ARTICLE 90 -- INTRODUCTION

1- 1 - (Article 90): Reject

Figure 310-5. Interpolation chart for cables in a
duct bank I_1 = ampacity for Rho-60, 50 LF;
 I_2 = ampacity for Rho-120, 100 LF;
Desired ampacity = $F \times I_1$

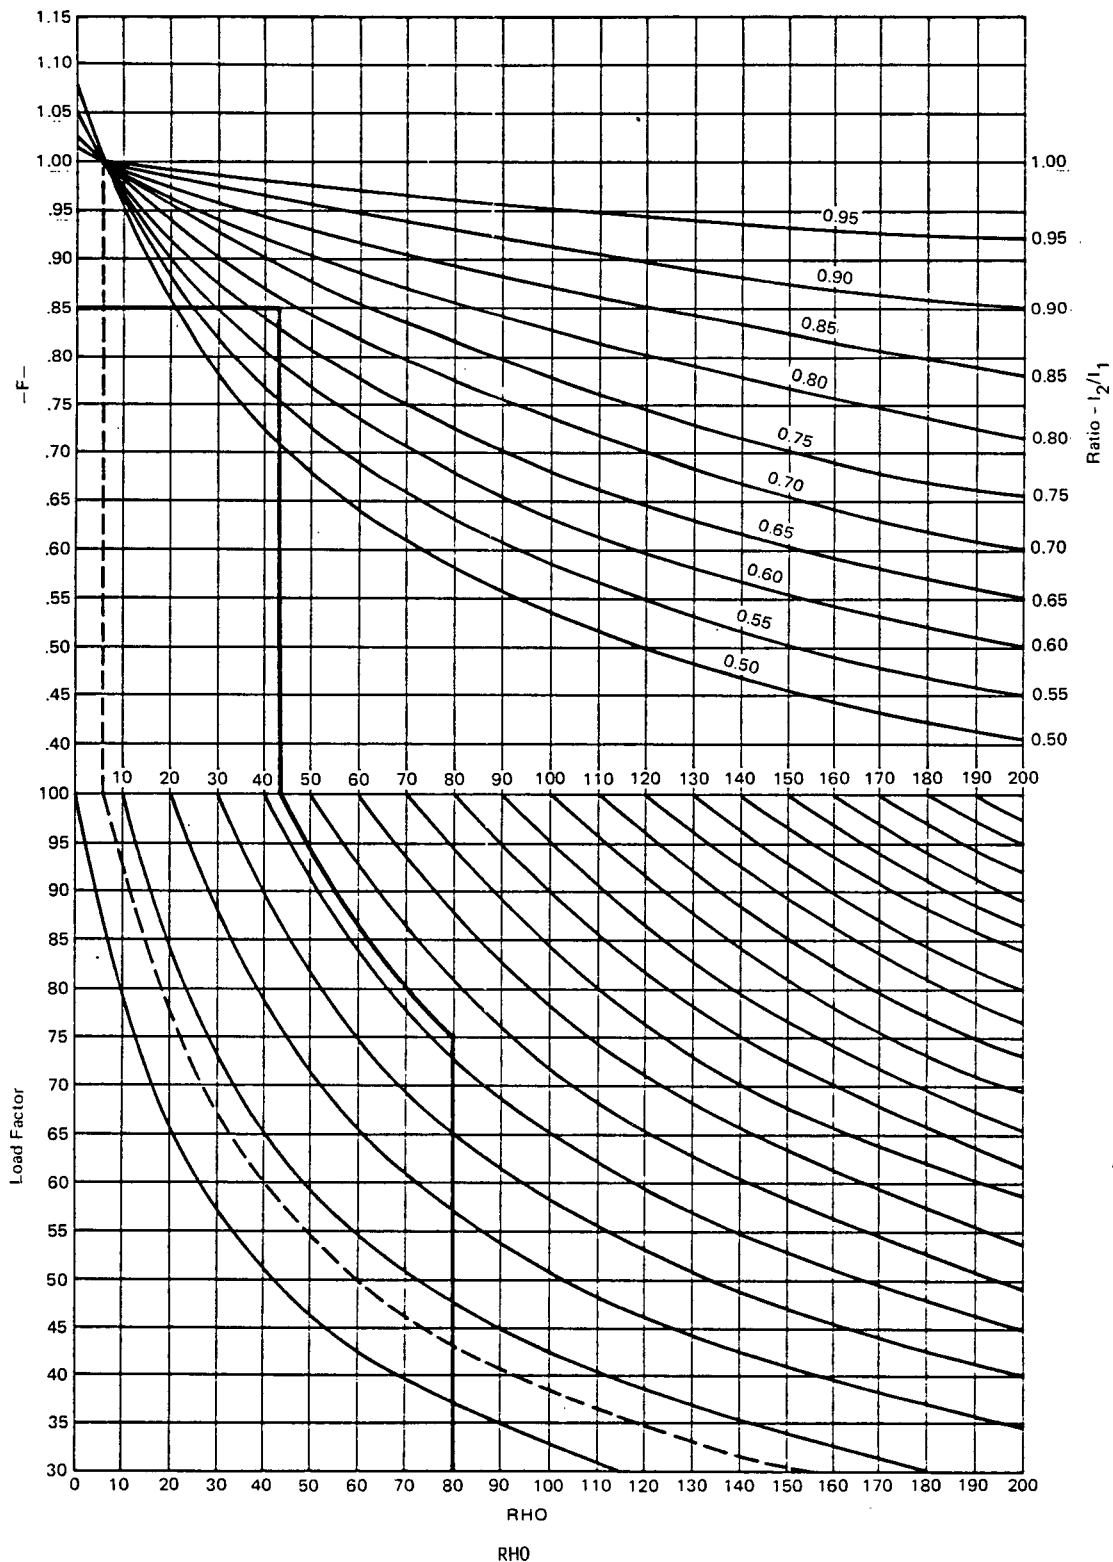
Figure 310-5 may be used for interpolation or extrapolation for values of Rho and load factor for cables installed in ducts. The upper family of curves shows the variation in ampacity and Rho at unity load factor in terms of I_1 , the ampacity for Rho = 60 and 50% load factor. Each curve is designated for a particular ratio I_2/I_1 where I_2 is the ampacity at Rho = 120 and 100% load factor.

MCCLUNG: This table is essential to allow the user to vary the value of Rho from 60 to 120 and the load factor from 50% to 100% without having to make calculations.

6- 168 - (Figure 310-1, Notes for all details): Accept in Principle

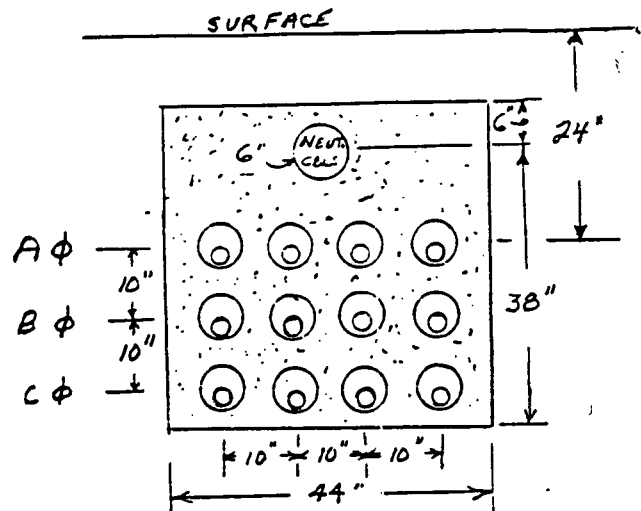
RECOMMENDATION: Add new Note 2 as indicated below. Renumber existing Notes 2 and 3 to become 3 and 4, respectively.

2. Burial depths may be increased in part(s) of the duct run to avoid underground obstructions without decreasing the rated ampacity of the conductors. The total length of parts of the duct run increased in depth to avoid obstructions must be less than 25% of the total run length, or else the ampacity reduction factor of Section 310-15(h) must be applied.

Figure 310-2 Cable installation Dimensions for 2000, 2500, and 3000 Ampere Duct Banks, Four Single Conductor Cables Per Phase, Rated 0 through 2000 Volts, in Nonmagnetic Underground Electrical Ducts (One Conductor Per Electrical Duct).

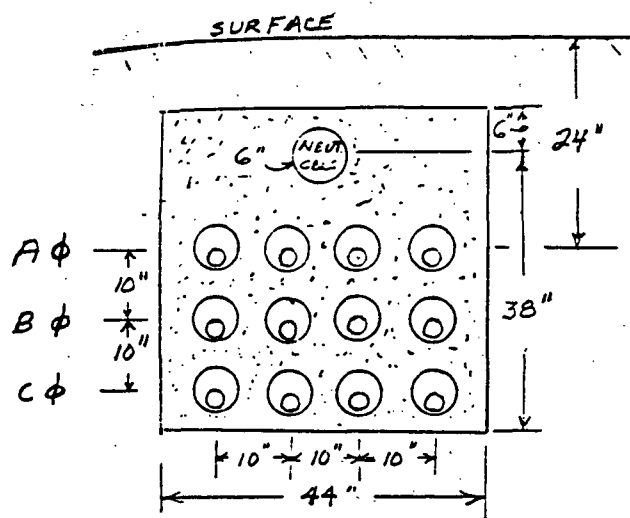
SUBSTANTIATION: This Figure provides ampacities for high ampacity duct banks where it is required, or desired, to limit the number of conductors per phase. Ampacities are included for Rho = 60, LF = 50 and Rho = 120, LF = 100 so that the ampacity of the banks for any normal range of Rho and LF can be determined without calculation by the use of Figure 310-5.

FRASURE AND SEGALL: This proposal is necessary to add high ampacity duct banks having no more than four ducts per phase to the Code.

Figure 310-3 Cable Installation Dimensions for 4000 Ampere Duct Bank, Five Single Conductor Cables Per Phase, Rated 0 through 2000 Volts, in Nonmagnetic Underground Electrical Ducts (One Conductor Per Electrical Duct)

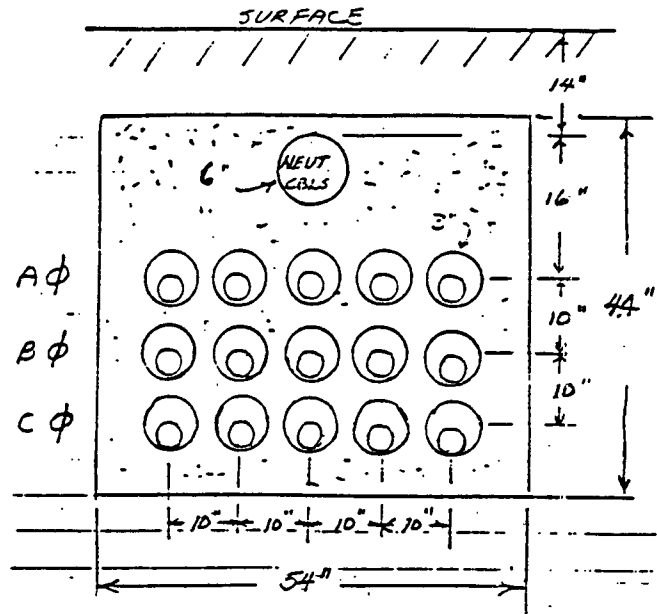
SUBSTANTIATION: Existing tables in the NEC do not reference duct bank ampacities in excess of 1800-2000 amperes.

Apparently there are enough large ampacity duct bank requirements that users have requested these configurations for ready reference.

PANEL COMMENT: Table lacks the factors necessary to vary Rho and load factors without calculations.

Figure 310-3 Cable Installation Dimensions for 4000 Ampere Duct Bank, Five Single Conductor Cables Per Phase, Rated 0 through 2000 Volts, in Nonmagnetic Underground Electrical Ducts (One Conductor Per Electrical Duct)

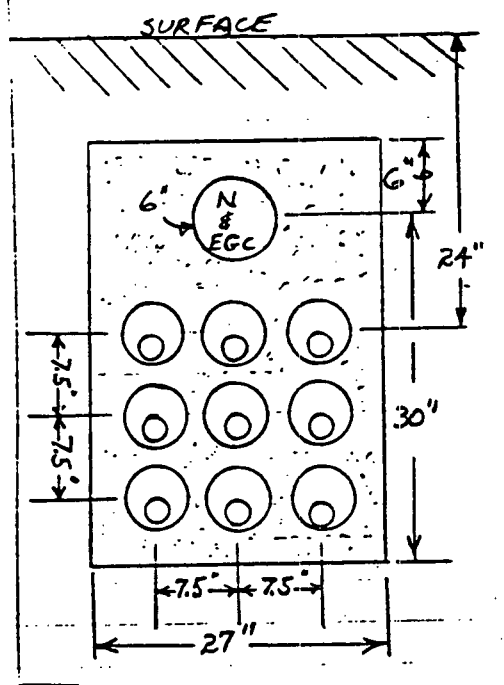
Ampacities are included for Rho = 60, LF = 50 and Rho = 120, LF = 100 so that the ampacity of the bank for any normal range of Rho and LF can be determined without calculation by the use of Figure 310-5.

FRASURE AND SEGALL: This Figure is useful for underground duct bank designs rated between 3243 and 5405 amperes, or 4000 amperes at 100% load factor. It is needed for some very large installations.

Figure 310-4 Cable Installation Dimensions, High Ampacity Duct Banks, Nine Single Conduit Cables per Phase, Rated 0-2000 Volts, in Underground Electrical Ducts (Three Conductors Per Duct)

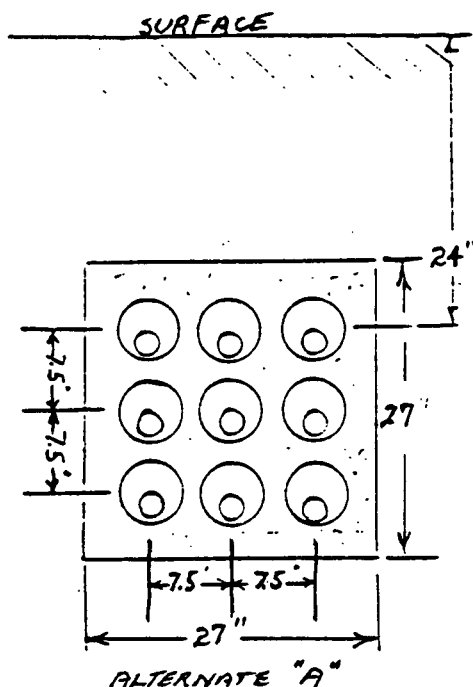
SUBSTANTIATION: At the suggestion of users, two tables have been created for high ampacity duct banks that use a maximum wire size of 500 MCM, 75°C, single conductor, since this is the largest size that is usually available without special order. This is one of the tables using three conductors per duct. A companion submission, Figure 310-6, uses the same wire size and one conductor per duct for increased ampacity. Note, that by varying Rho to 60 and LF to 50, typical commercial numbers, the ampacity can be increased approximately 50%.

FRASURE: This Figure is needed for high ampacity duct banks where space permits only nine ducts and cable sizes are readily available only up to 500 MCM, copper. The Figure is extremely useful. It assumes a 480/277 volt installation.

Between the limits of Rho = 60, LF = 50 and Rho = 120, LF = 100, the Table shows ampacity variations of 1395 to 3375 amperes per phase using proposed Figure 310-5, Proposal 6-71.

Figure 310-6. Cable Installation Dimensions, Single 500 MCM Copper Conductors Per Duct, Rated 0-2000 Volts, in Underground Electrical Ducts

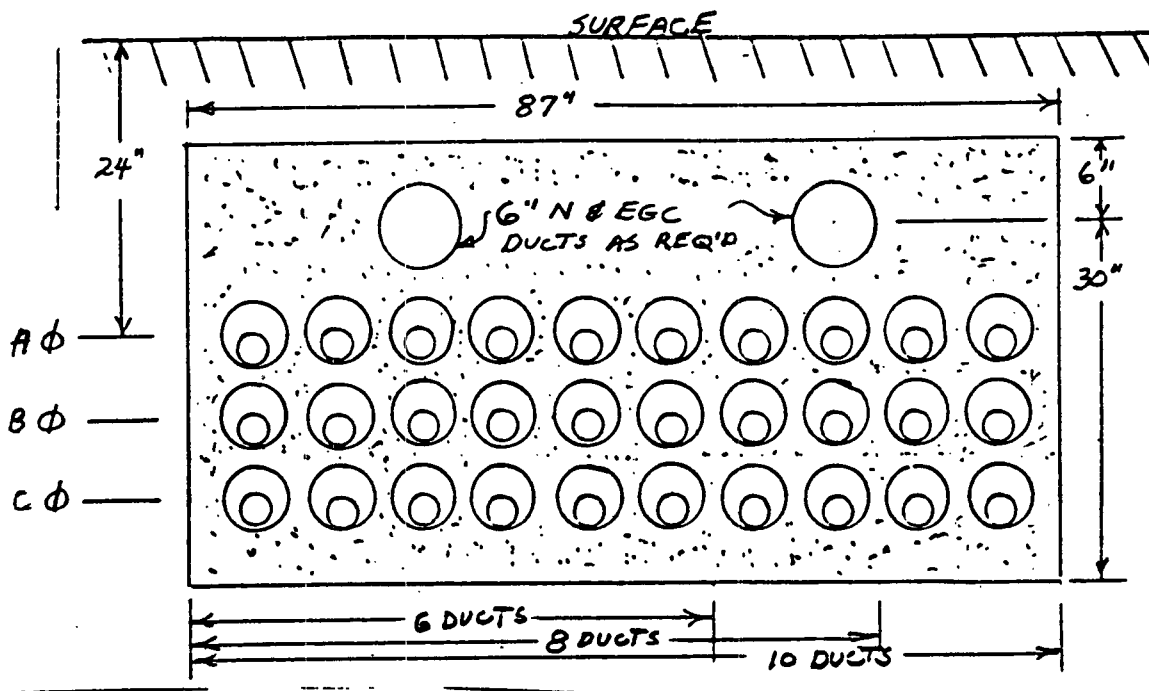
SUBSTANTIATION: At the suggestion of users, two tables have been created for high ampacity duct banks that use a maximum wire size of 500 MCM, 75°C, single conductor, since this is the largest size that is usually available without special order. This is one of the tables using a single conductor per duct. A companion submission, Figure 310-4, uses the same wire size and three conductors per duct.

FRASURE AND SEGALL: This proposal was submitted in response to several requests from the field. Neutral configuration is in accord with 300-5(i); Exception No. 2. When used in conjunction with proposed Figure 300-5, it permits design ampacity variations from 1844 amperes to 4225 amperes using 500 MCM Code conductors. It is not as space efficient as some of the other proposed tables, but is useful when time does not allow for the purchase of larger conductors. This is one of four critical submittals that permits knowledgeable design of high ampacity underground duct banks.
